Planning Application Under Section  
175 of the Planning and Development  
Act 2000 (as amended) for Phase 2 of  
Mooretown, Swords, Co. Dublin

**RESPONSE TO SUBMISSIONS**

### 7244\_RP01a\_Response to Submissions

Figure 3-1: Extract from drawing no. L102, prepared by Simon Ronan Landscape Architects (with additional annotation by BSM)

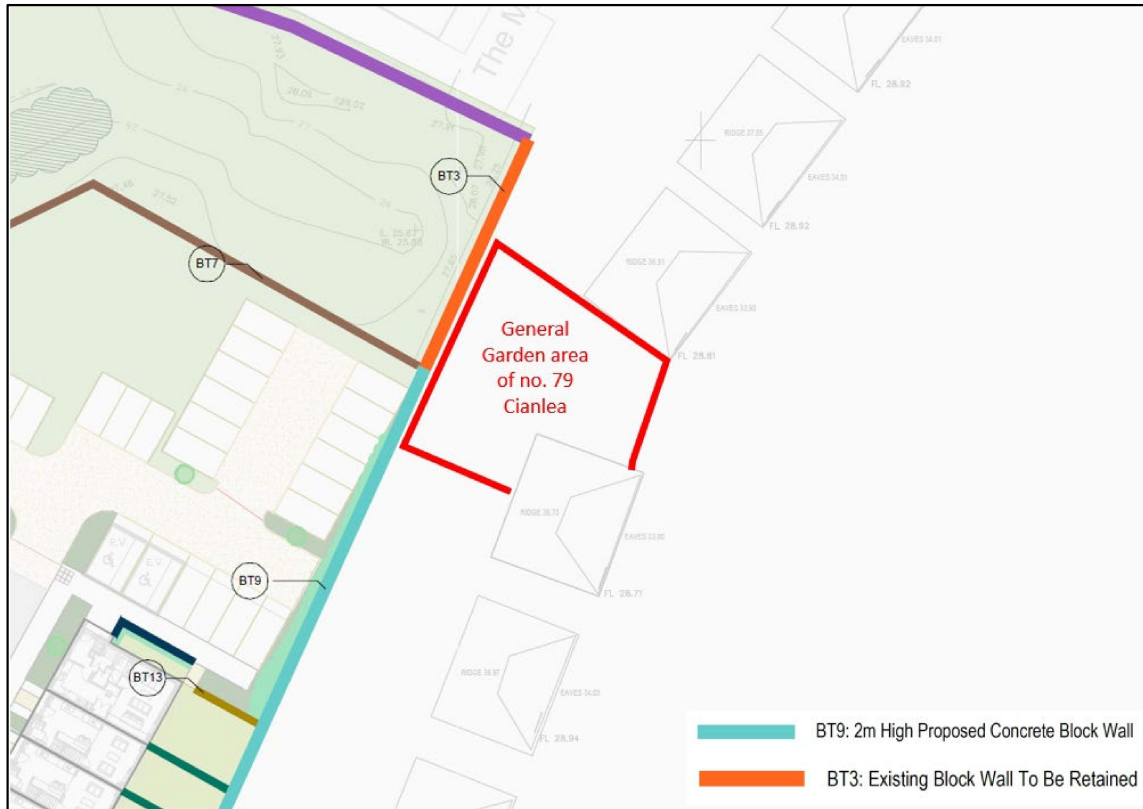
The Applicant notes the concerns raised in the submission from Maria McKittrick.

Where car parking is proposed within the subject site adjacent to the boundary wall of No. 79 Cianlea, a further 2m high concrete block wall will be constructed within the subject site, adjacent the existing boundary wall.

Where an existing boundary wall separates no. 79. Cianlea and the proposed open space within the site, the boundary wall will be retained in its current form. As this is an established boundary wall and no structures are proposed at this location, there is no proposal to increase its height.

Please refer to **Figure 3-1** which is an extract from the proposed boundary treatment plan, with some additional annotation by BSM generally outlining the property of no. 79. Cianlea.
